**CHANGE IN RIBBON SHIFT MAGNET ARMATURE (TP192908) AND
BLOCKING LINK (TP192901); NEW UP-STOP BRACKET (TP195485)**

APPARATUS AFFECTED: 35A and 35B Tape Typing Unit (LTP800 and 801) used in 35AB, 35AD and 35AE Teletypewriter Sets.

SECTION 574-231-800

3. Armature Upstop Adjustment

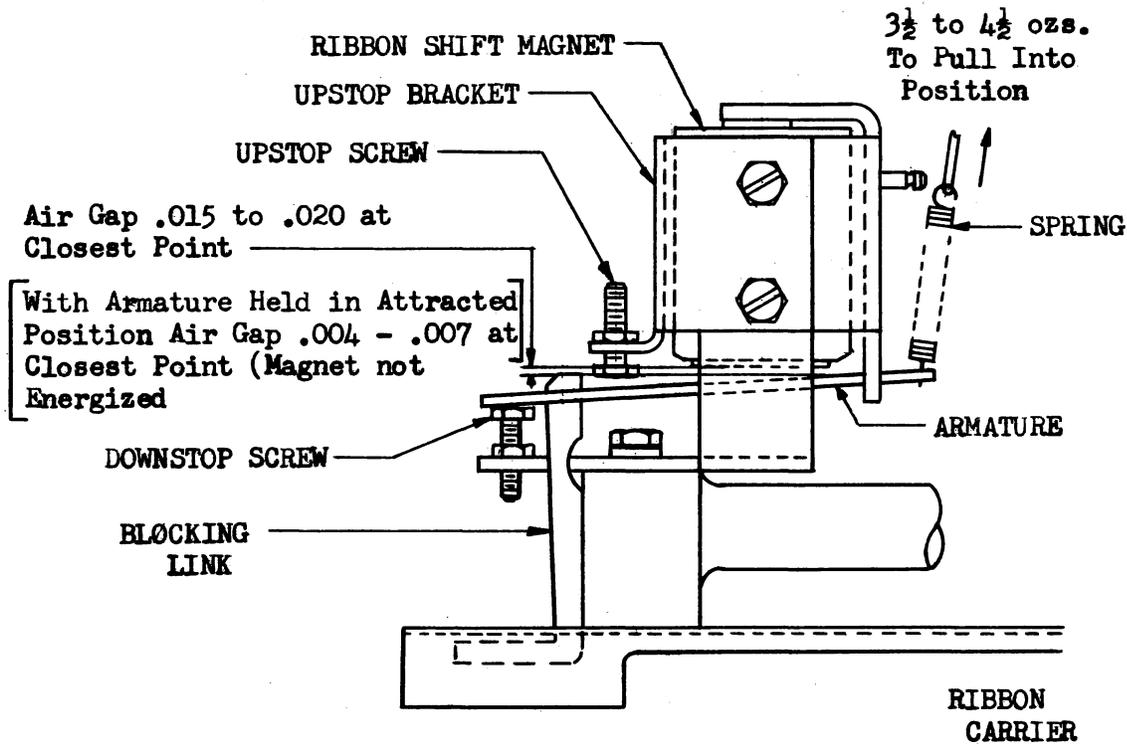
REASON FOR CHANGE: To assure proper service life from the ribbon shift magnet armature and blocking link.

CHANGE: The armature material has been changed, the blocking link design modified, and an armature upstop bracket with adjusting screw, lock nut and mounting screws added.

- a. With the rocker bail in the extreme left position and the ribbon carrier biased in a downward direction, there should be some to .005 clearance between the top surface of the blocking link and the lower surface of the ribbon carrier.
- b. To adjust: Position magnet armature downstop screw with the locknut loosened.

- a. With the armature resting on the downstop screw there should be .015 to .020 inch clearance between the magnet core and the armature at the closest point.
- b. To adjust: Position magnet bracket with the screws loosened. Check for binds.

- a. With the armature held against the upstop screw (Magnet is not to be energized) there should be .004 — .007 inch clearance between the magnet core and the armature at the closest point.
- b. To adjust: Position the magnet armature upstop screw with the locknut loosened.
